METROPOLITAN GOVERNMENT OF NASHVILLE AND DAVIDSON COUNTY

STAFF RECOMMENDATION
3501 Bryon Avenue, Lot 3
February 20, 2013

Application: New construction-infill
District: Elmington Place Neighborhood Conservation Zoning Overlay
Council District: 25
Map and Parcel Number: 10410004700
Applicant: Kevin Smith/ Byron Avenue 3501, LLC
Project Lead: Robin Zeigler, robin.zeigler@nashville.gov

FOOTING & FOUNDATION PLAN

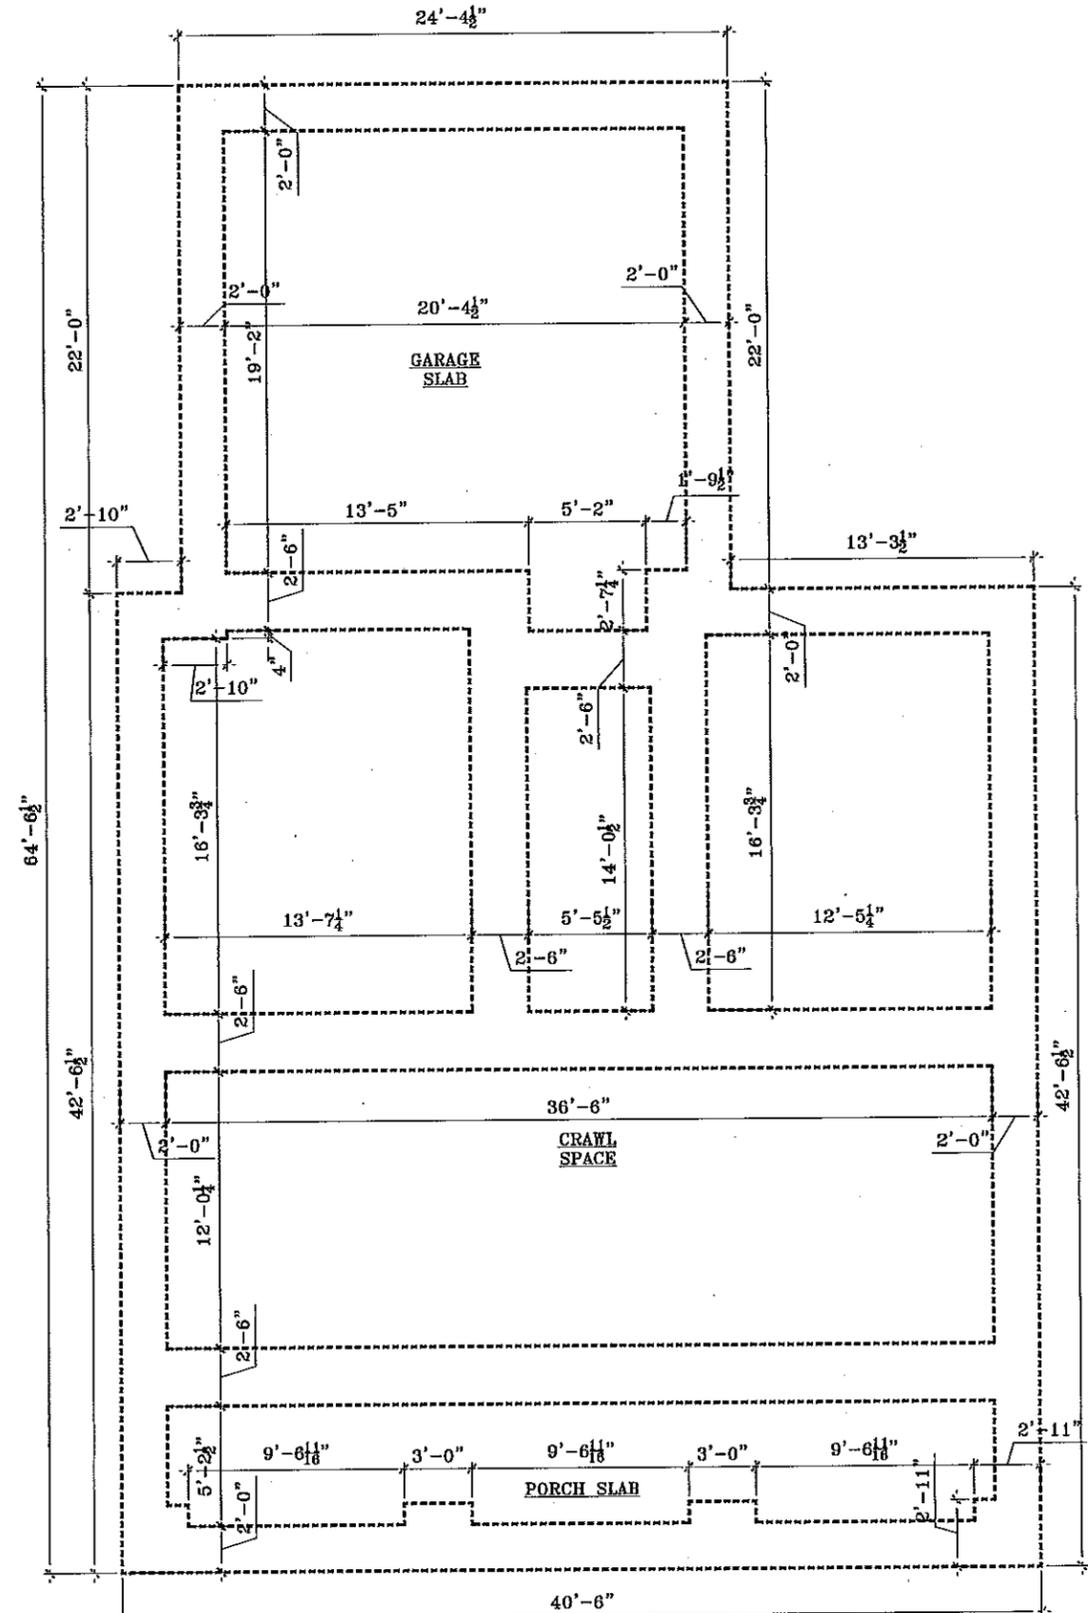
Materials, Texture, Details, and Material Color: The foundation material is stone for the porch, but not indicated for the rest of the building, the cladding is wood shingle and lap siding with a six inch (6") reveal on the front façade and lap siding on the sides and back. Changes in material typically happen at the floor level rather than vertically. Staff recommends that the wood shingle be used on at least the front and sides or the entire building be lap sided.

- The applicant provide revised drawings with major measurements called out;
- Staff provide final review of windows, doors, roof color, brick, stone, and trim, fence and chimney materials;
- Staff approve the foundation material;
- Material changes on the body of the house happen at the floor level on at least the front and sides of the house;
- The side wall dormers be redesigned to be roof dormers that sit off the ridge and off the wall by a minimum of two feet (2') each; and
- The porch be redesigned not to have conditioned space above.

ELEVATIONS

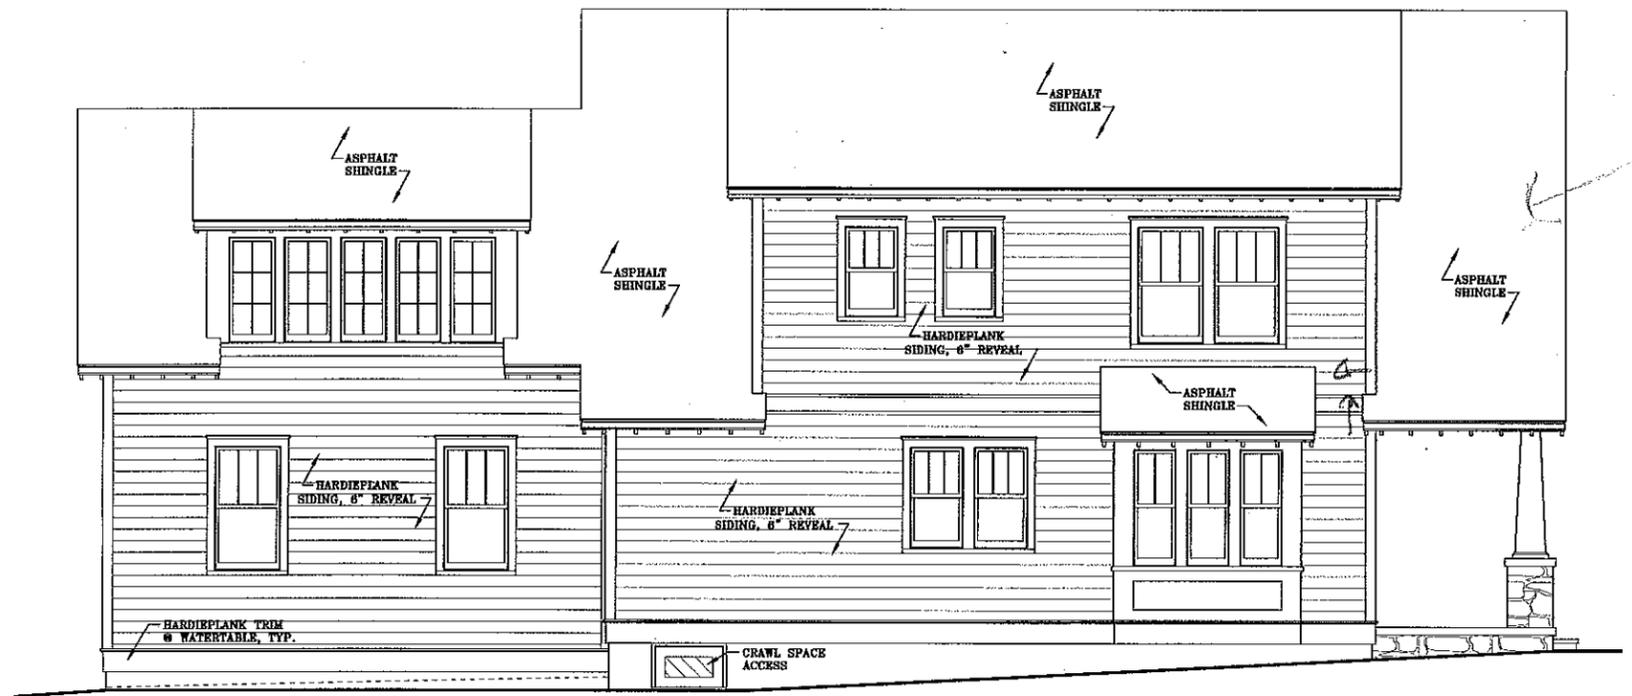
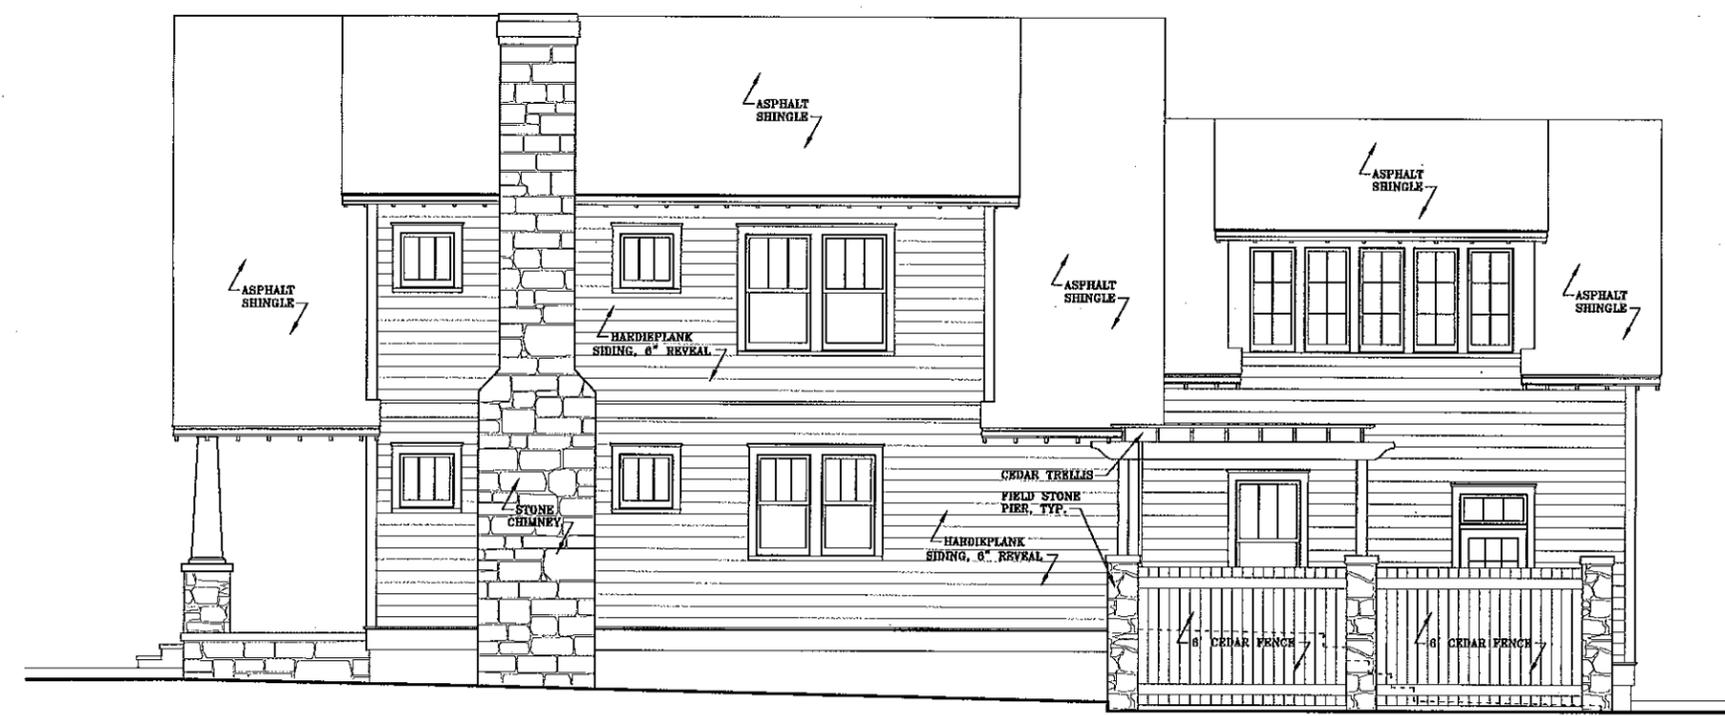
The porch roof is approximately ten feet (10') tall from finished floor and includes a gable roof with finished space above. There are no examples in the overlay of second-story finished space above a porch. Staff recommends pushing the finished space back into the bulk of the house and creating a simple gable or shed roof porch roof.

The wall dormers are another massing that does not appear in the district and contribute, along with the second-level finished space above the porch, to create a form not found in the overlay. Staff recommends that the dormers sit off the walls by a minimum of two feet (2') and off the ridge by a minimum of two feet (2'), which has been required of past projects.

Roof Shape: The proposed shape is a front gable home with large side wall dormers. The side gable form and pitch of 10/12 are found in the district and are appropriate. The wall dormers are not a feature of the historic overlay. See discussion above under "height and scale." With the condition that the dormers be roof dormers rather than wall dormers, staff finds the project to meet section II.B.e of the design guidelines.

With the conditions that the side dormers sit back a minimum of two feet (2') and off the ridge a minimum of two feet (2') and the front porch is redesigned to not have finished
